Application for Licence Amendment

Licence Number	L8454/2010/2
Licence Holder	Chichester Metals Pty Ltd
ACN	109 264 262
File Number	2010/003105
Premises	Christmas Creek Mine Site Tenements E46/610, E46/612, M46/320, M46/321, M46/322, M46/323, M46/324, M46/325, M46/326, M46/327, M46/328, M46/329, M46/330, M46/331, M46/332, M46/333, M46/334, M46/335, M46/336, M46/337, M46/338, M46/339, M46/340, M46/341, M46/342, M46/343, M46/344, M46/345, M46/346, M46/347, M46/348, M46/349, M46/350, M46/351, M46/352, M46/353, M46/354, M46/355, M46/403, M46/406, M46/412, M46/413, M46/414, M46/415, M46/416, M46/417, M46/418, M46/419, M46/420, M46/421, M46/422, M46/423, M46/424, G46/7, L46/49, L46/56, L46/58, L46/86, L46/87, L46/106, L46/111, E46/566 and L46/66 MULGA DOWNS WA 6751 As depicted in Schedule 1
Date of Report	05/04/2022
Decision	Revised licence granted

This Amendment Report documents the assessment of potential risks to the environment and public health from proposed changes to the emissions and discharges during the operation of the Premises. As a result of this assessment, Revised Licence L8454/2010/2 has been granted.

Figure 2: Proposed OPF1 Lump Plant Layout

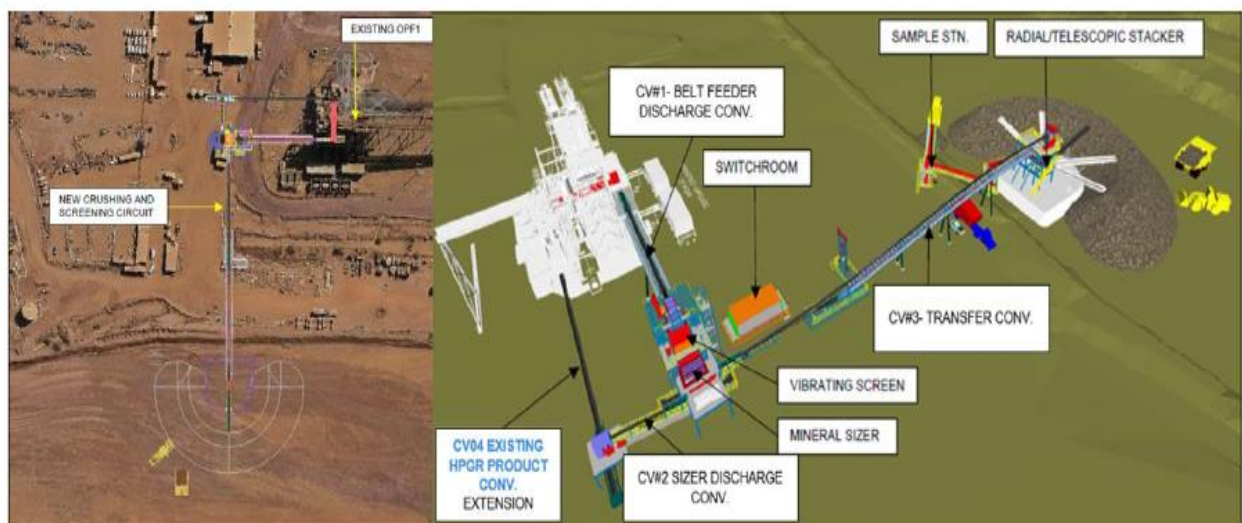
Condition	Summary of Licence Holder's comment	Department's response
	product" <ul style="list-style-type: none"> From "Conveyor to existing dry screening plant" to "Conveying system into existing plant" From "Radial telescopic stacker" to "Stacker" 	
	Delete reference to CAT 3516B within 2 x 1600 kW CAT 3516B emergency back up diesel gensets	Updated as requested.
12, Table 7	Delete references to CAT 3516B , within Emission Point column "6 x 1600 kW CAT 3516B Diesel Generator" And "2 x 1600 kW CAT 3516B emergency back up diesel gensets"	Updated as requested.
22, Table 14	Insert missing footnote for pH relating to Emission Point Reference L4.	Updated as requested.
Schedule 1: Maps Figure 18	Update with NEW layout of proposed OPF1 Lump Plant, as depicted below. Amend title and include the term 'indicative', "Figure 18: Indicative layout of OPF1 Lump Plant"	Updated as requested.
